PERMIT

A REPAIR

SEWAGE DISPOSAL SYSTEM
MARYLAND STATE DEPARTMENT OF HEALTH

16495 ED WARFIELD RD

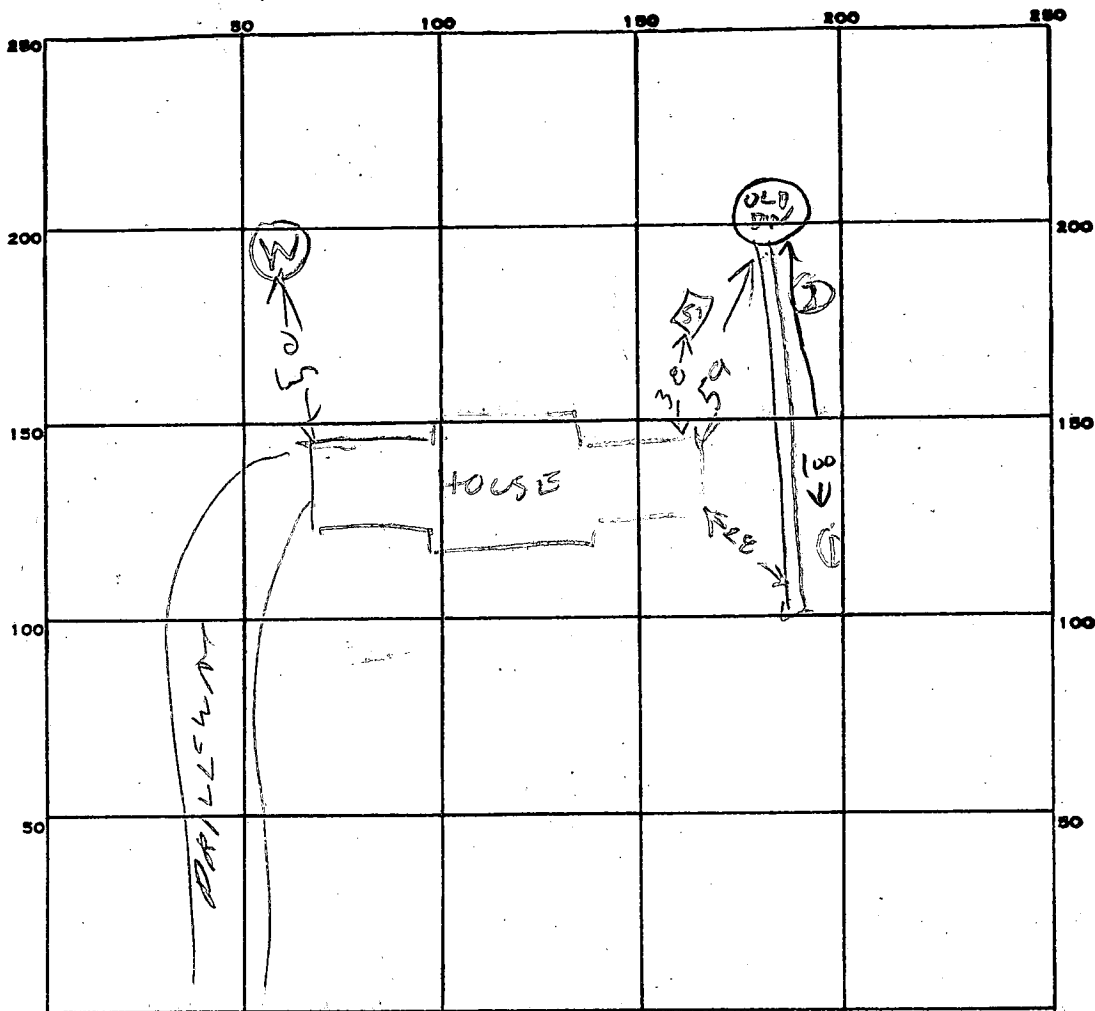
9/5/86 PLACE TRENCH OFF OLD DRY WELL
500 SOFT SIDE WALL AREA 10 1/2 FT DEEP INLET
5 1/2 FT DEEP 5 FT OF STONE 100 FT LONG
2 FT WIDE RA

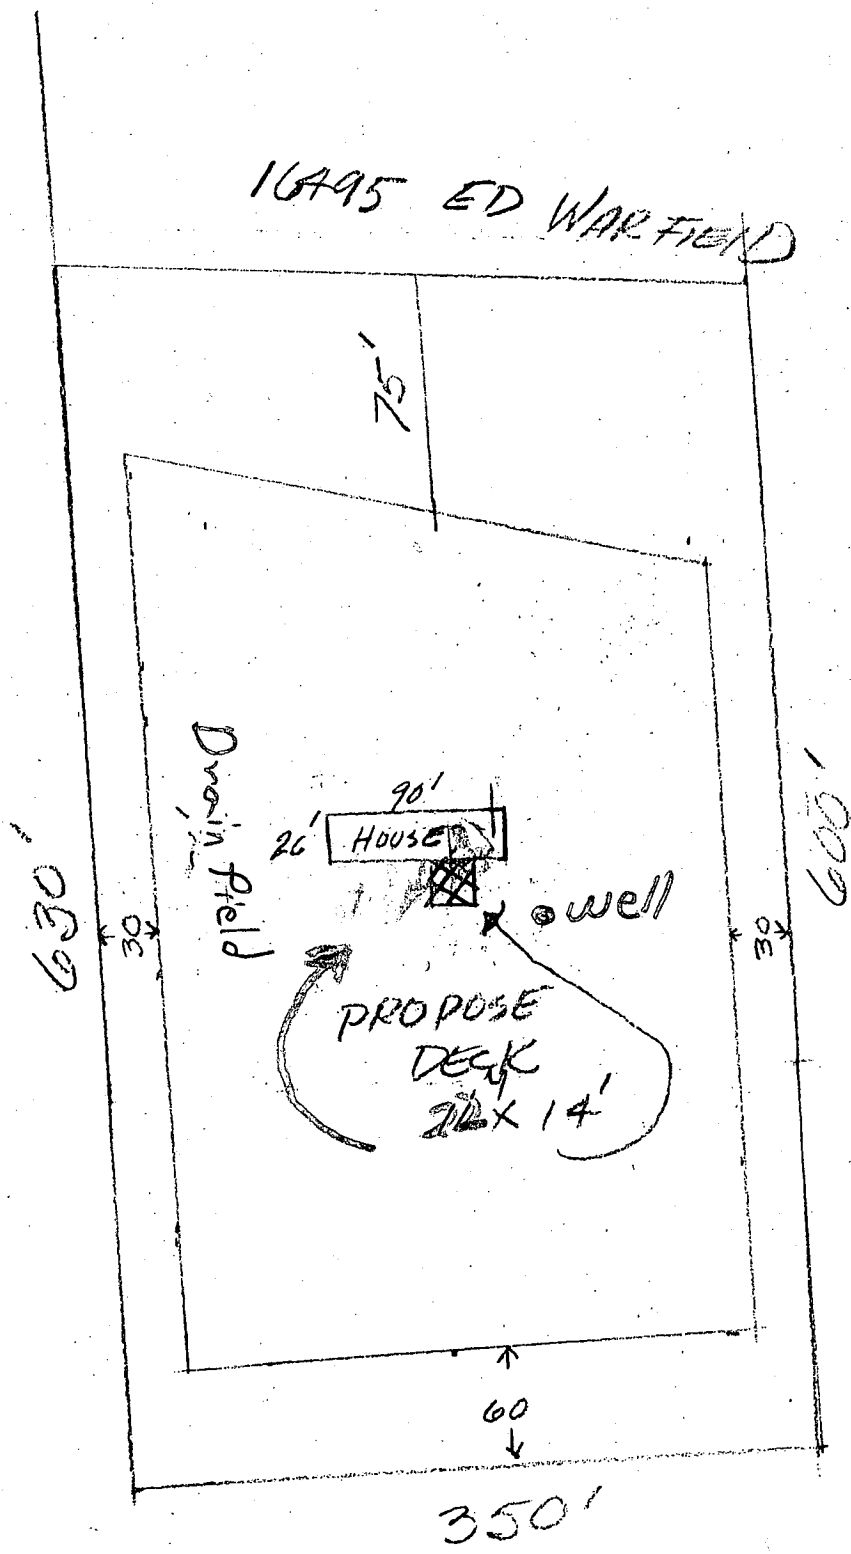
REMARKS 9/5/86 SOIL OK EXTEND TRENCH TO 100 FT

& ADD STONE & CALL RH

9/8/86 TRENCH EXTENDED & STONE ADDED RH

6/11/97
Shown deck will have no impact to the existing well and septic OK to proceed.
